Colliers Hill

Bridgewater P.U.D. Amendment No. 6 and Rezone
Board of Trustees | August 24, 2021

Proposed Updates

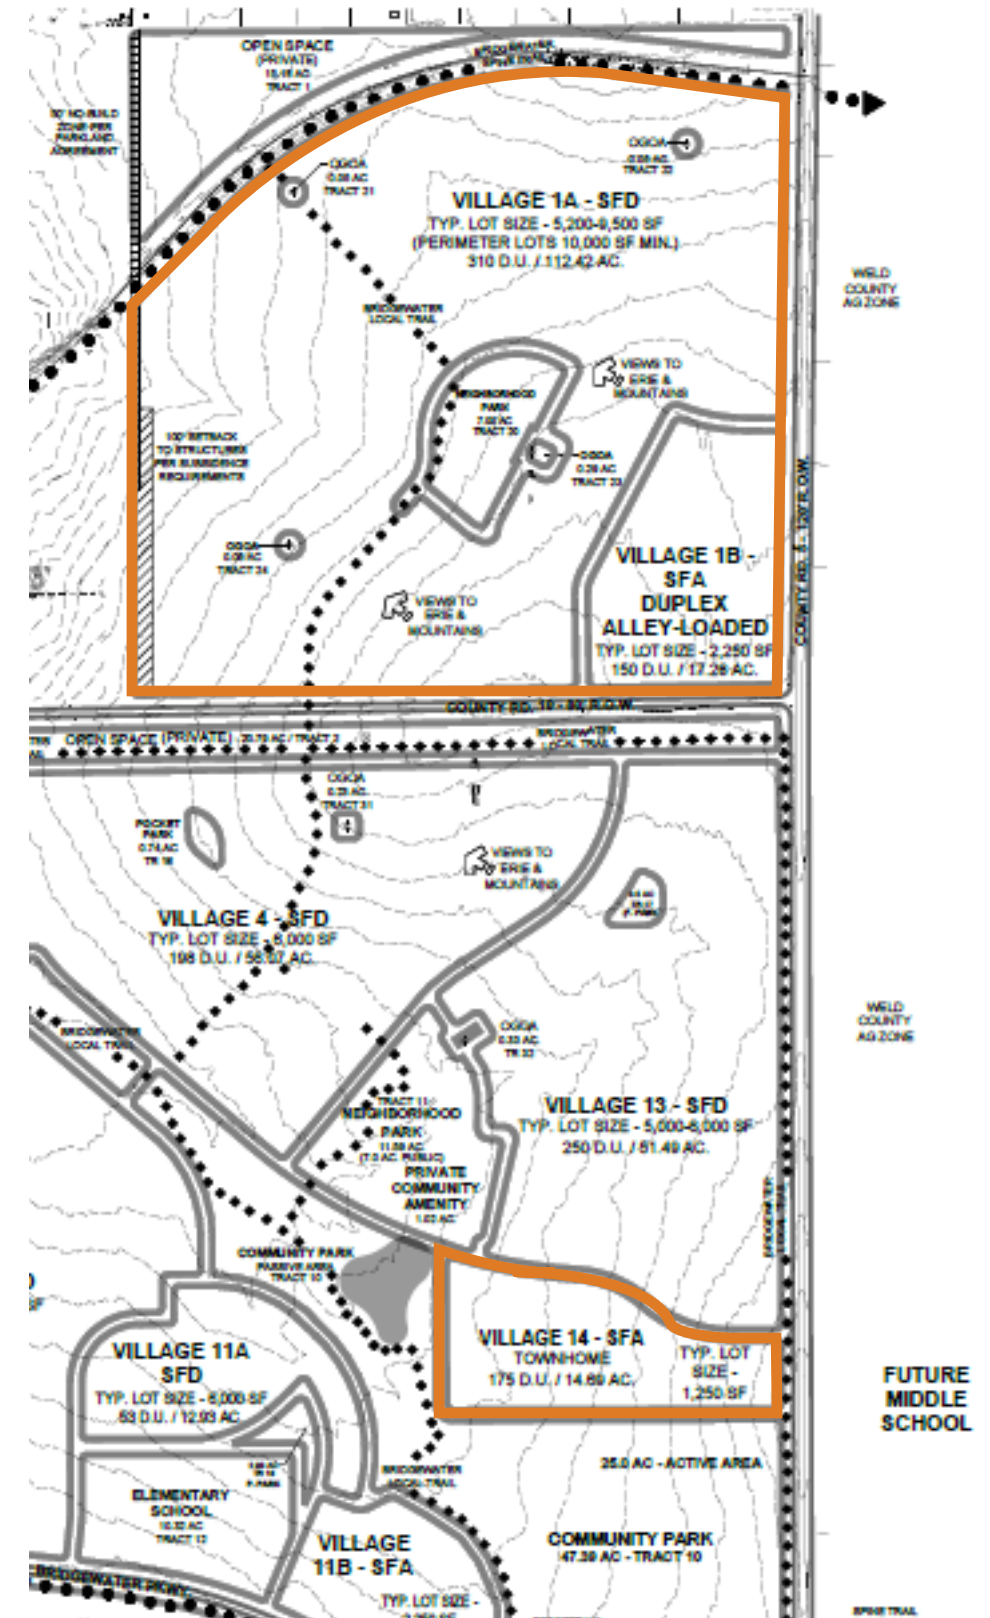
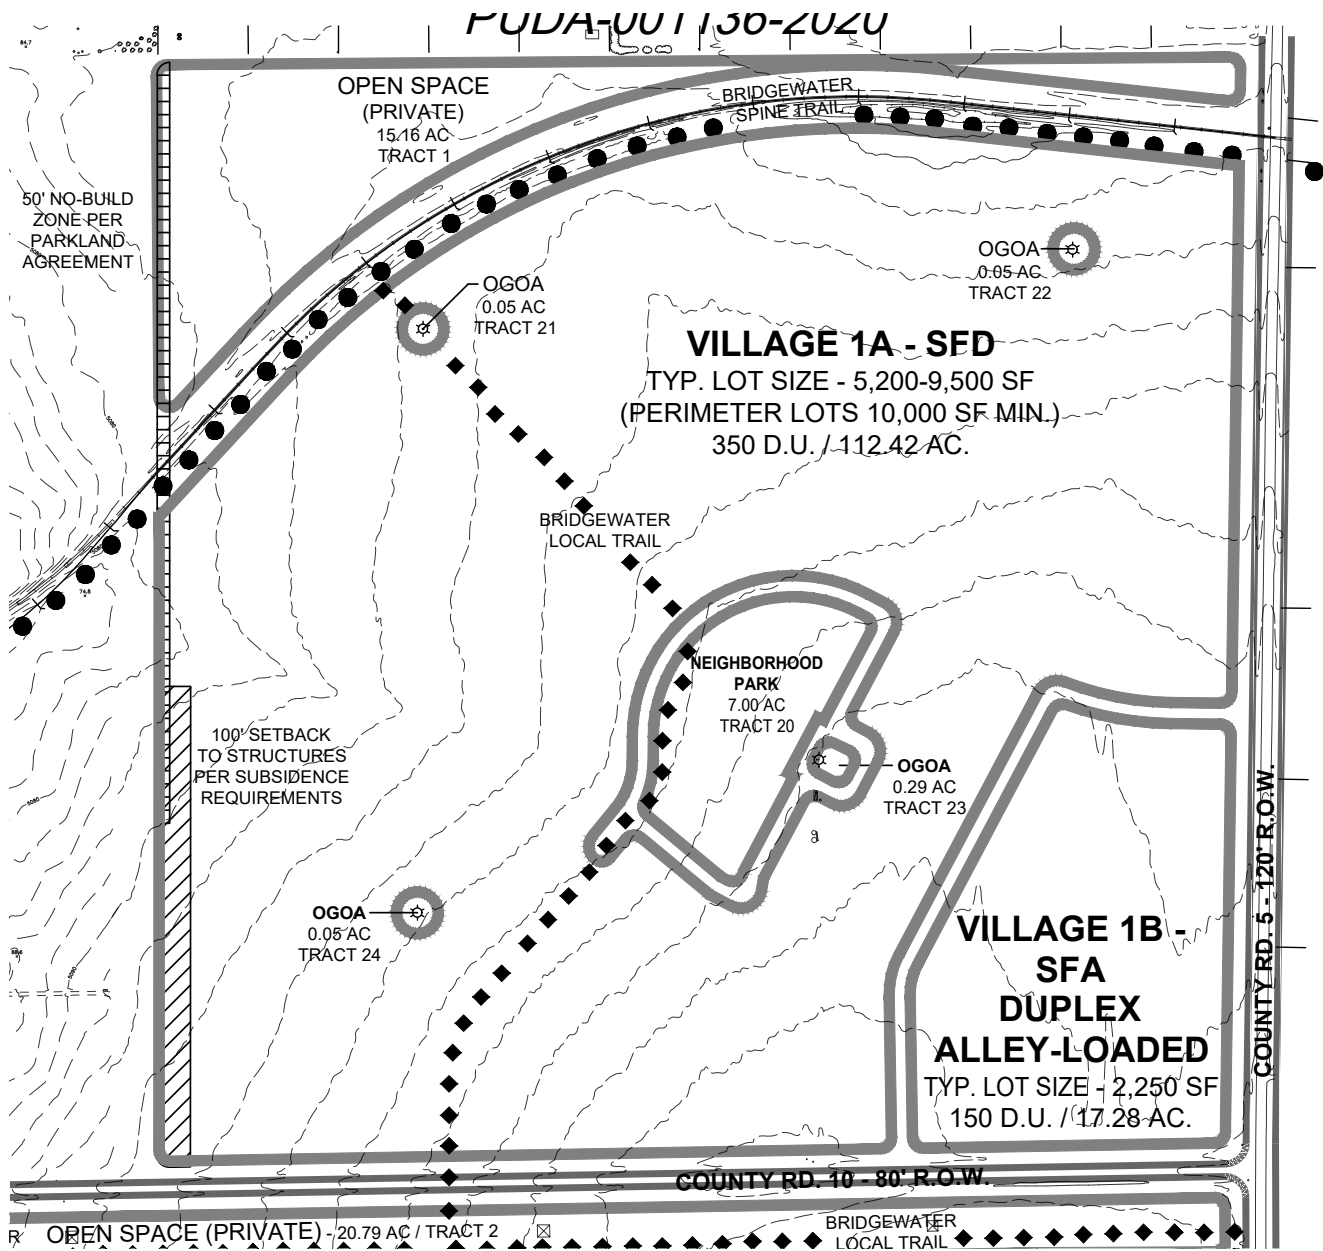
- Proposes the distinction between Village 1A and Village 1B
- Updates boundaries to reflect current and in progress oil and gas removal
- Establishes dimensional standards for SFA-Townhomes

Proposed Zoning

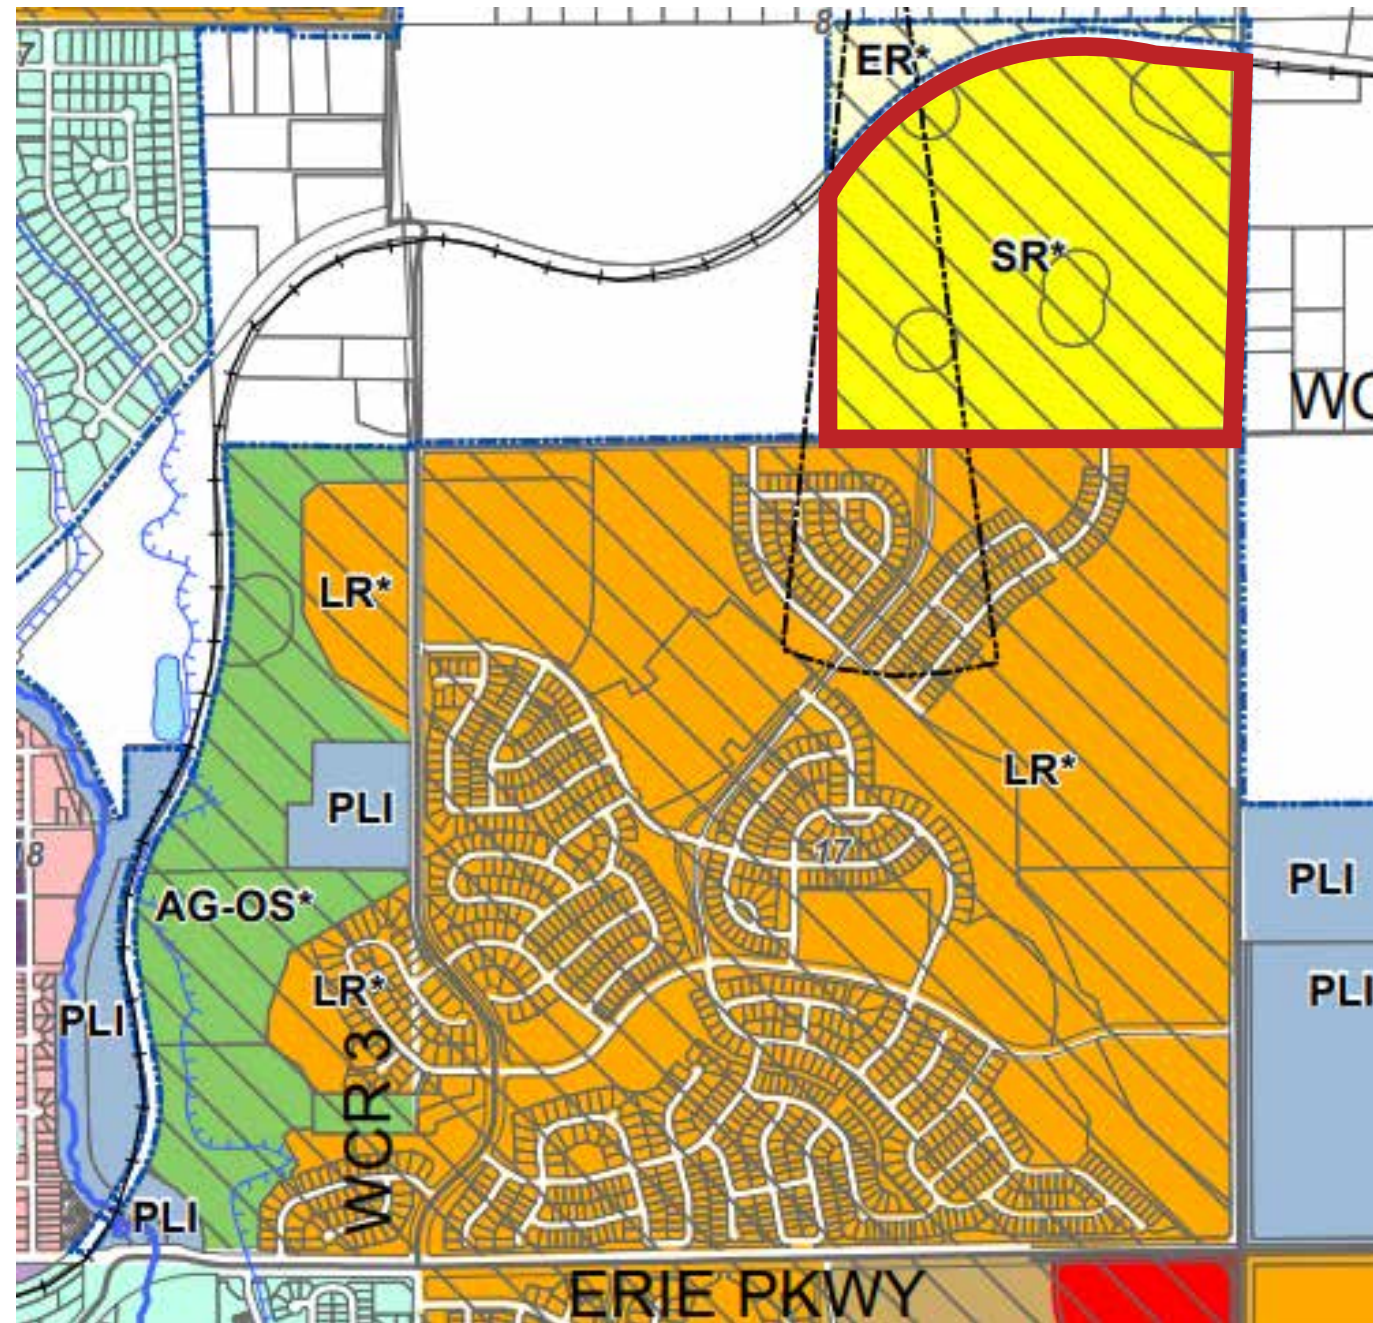
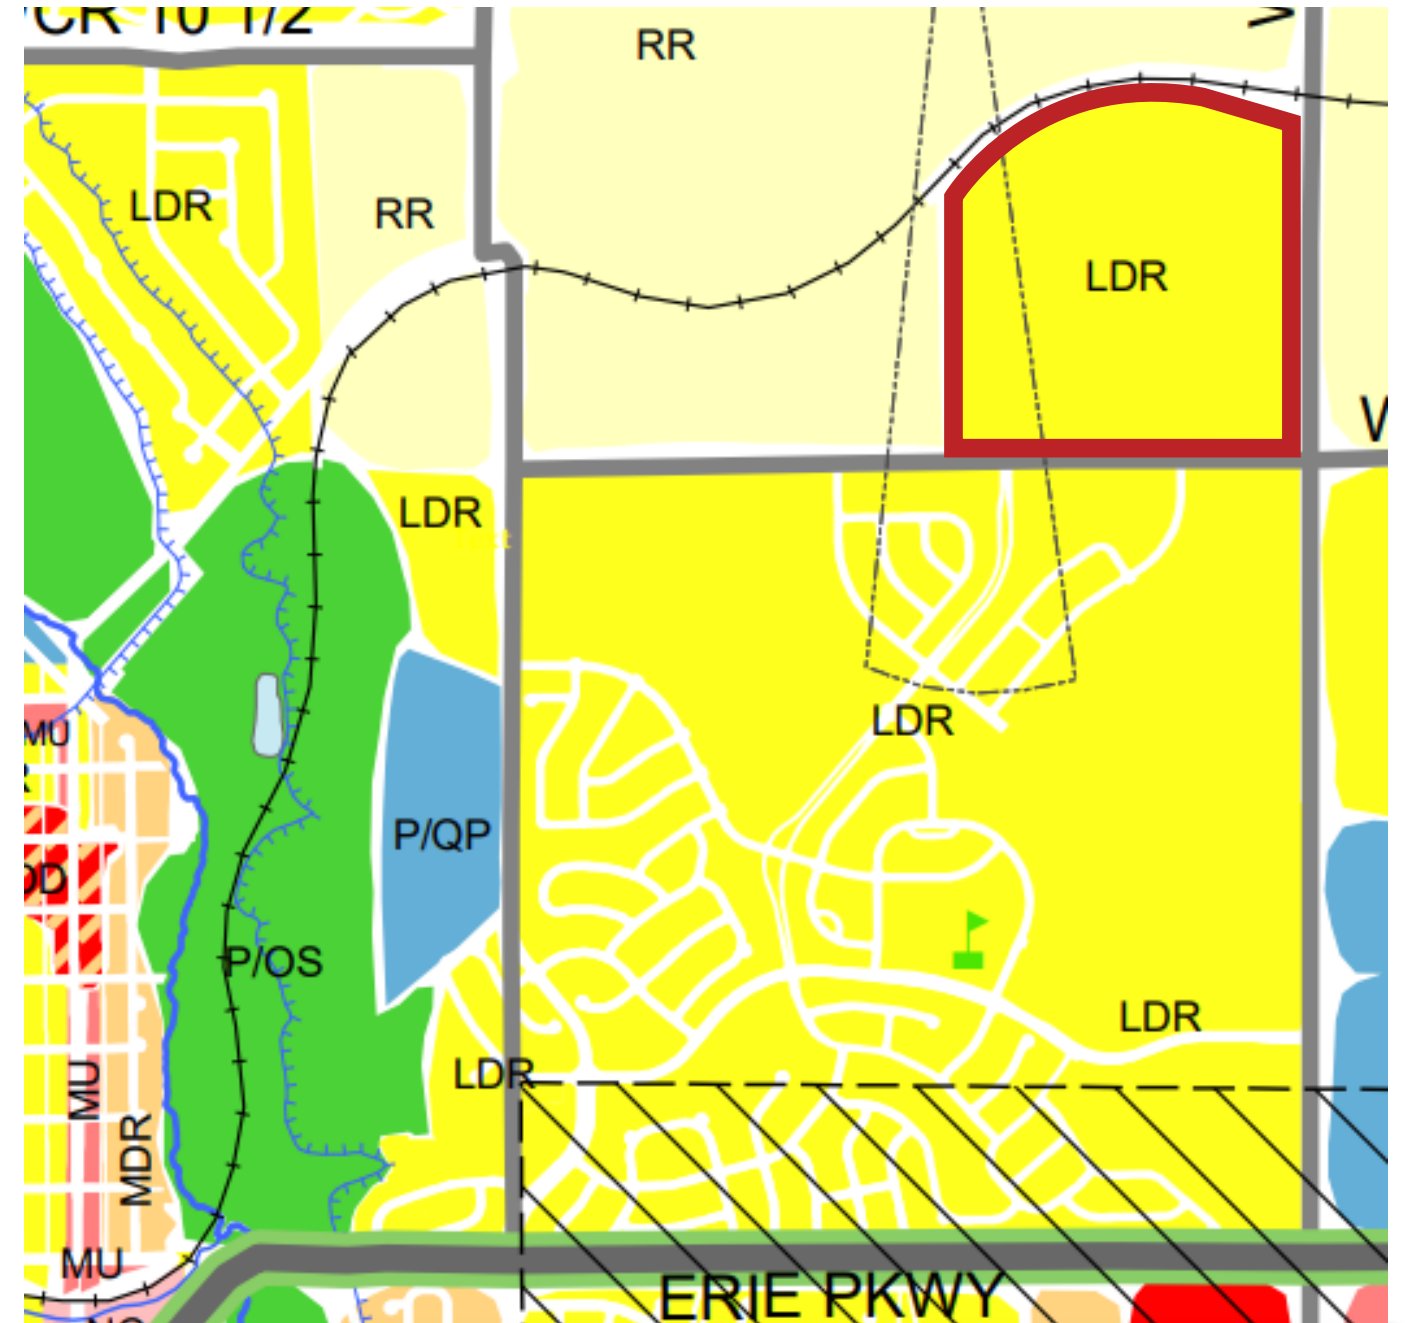
- Proposed rezoning from Suburban Residential (SR) to Low-Density Residential (LR)
- Consistent with the Colliers Hill community
- Maintains adherence with the total maximum units allowed
- Consistent with the Town of Erie Comprehensive Plan
- Allows for additional alternative product types such as duplexes
